Wayne Ave and Dale Drive Redesign Concept

A Community-Sourced Solution for a
Safer, Human-scale Streetscape

Premise: The current configuration of Wayne Avenue and the proposed Purple Line (PL) Dale Drive Station design are potentially UNSAFE. There must be an alternative.

Current Dale Drive Station PL Design –

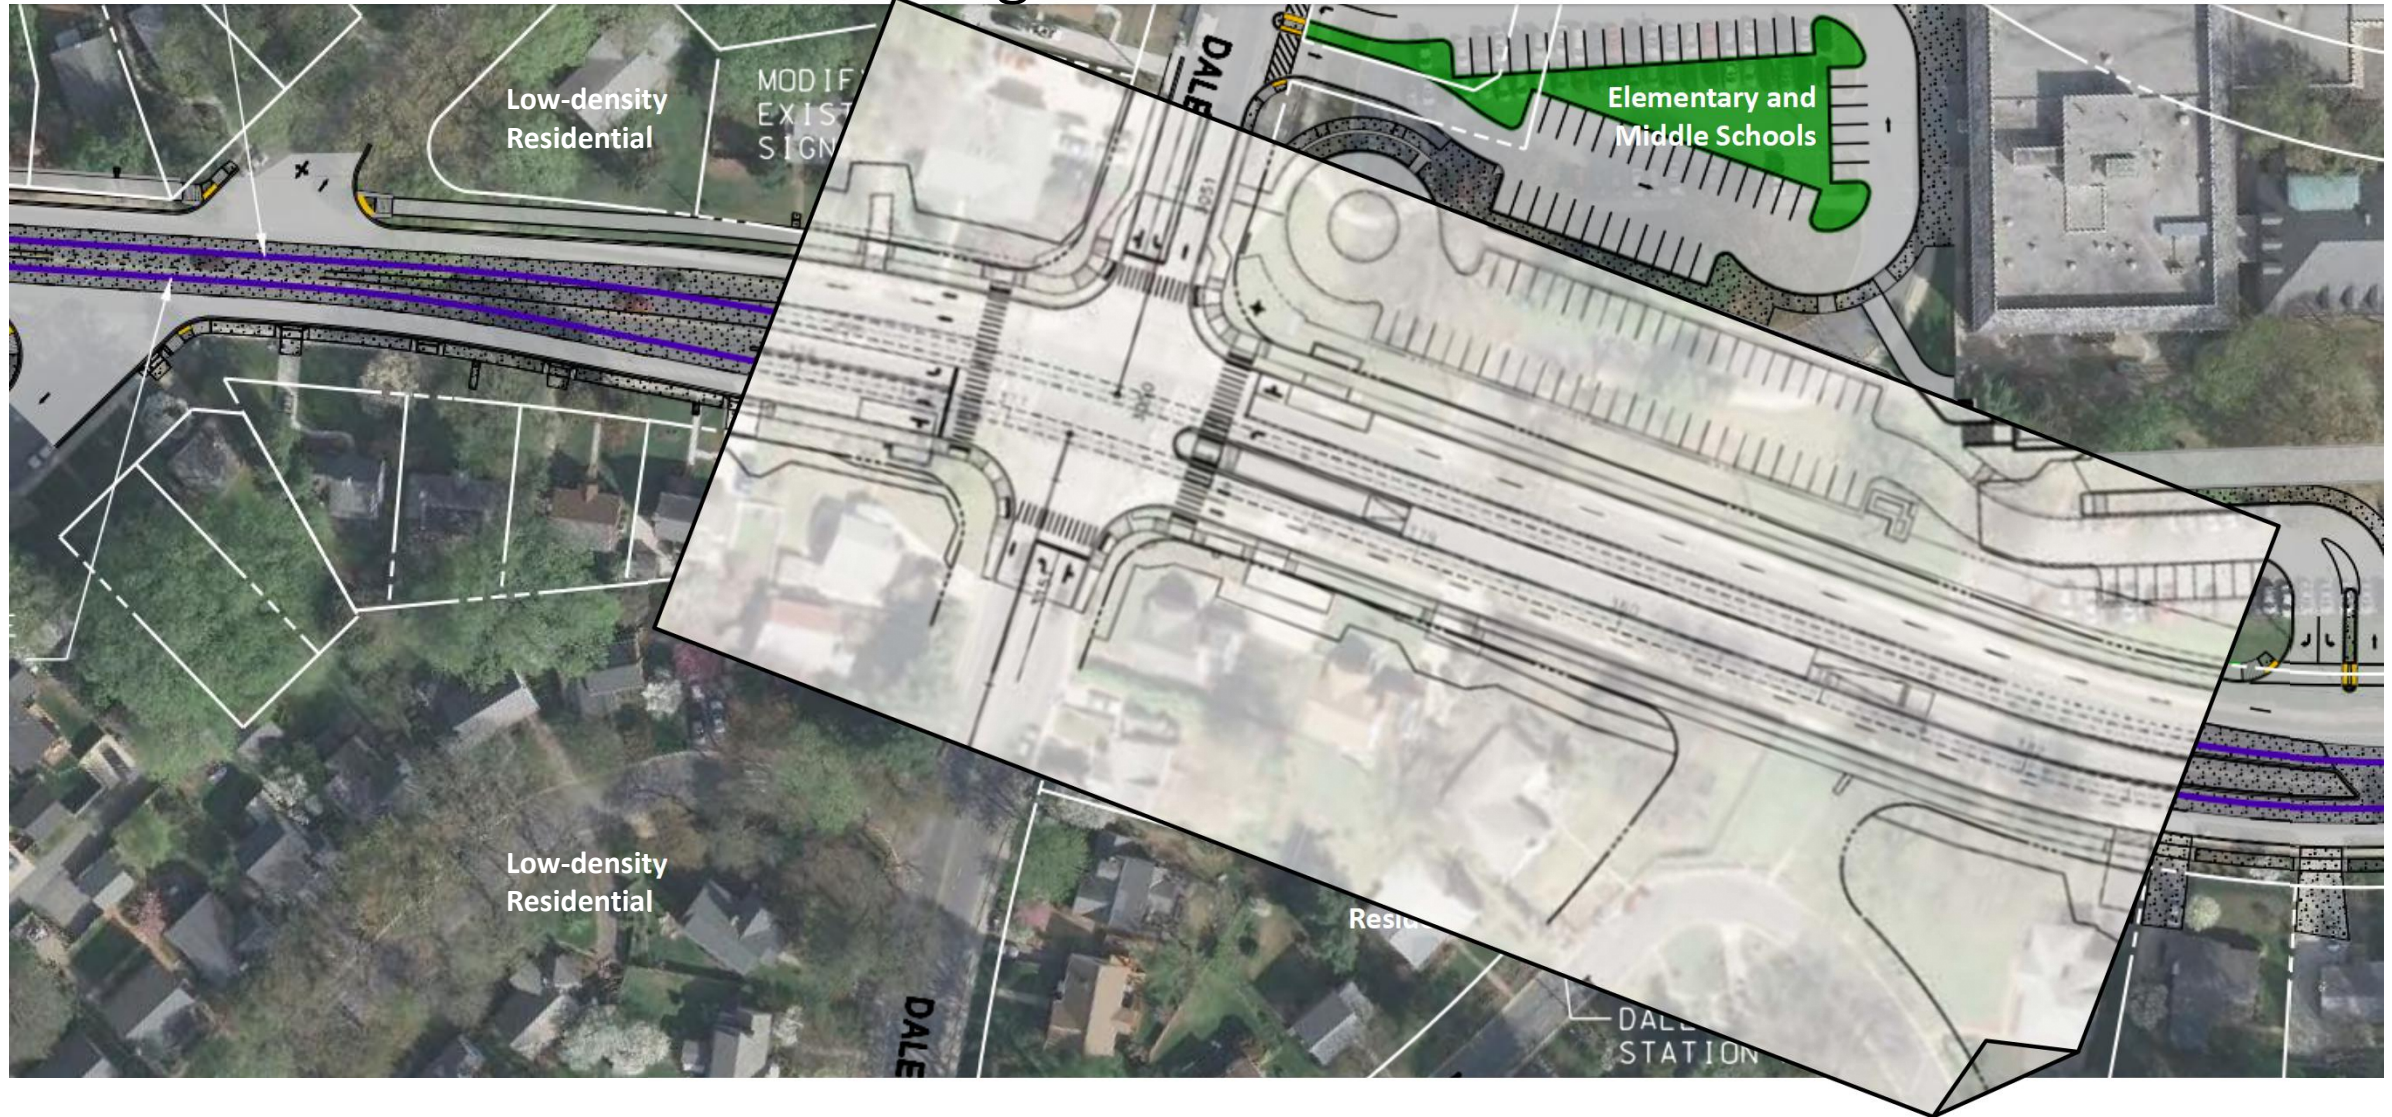
In response to community pressure, one lane east of Dale reduced;
west of Dale remained unchanged
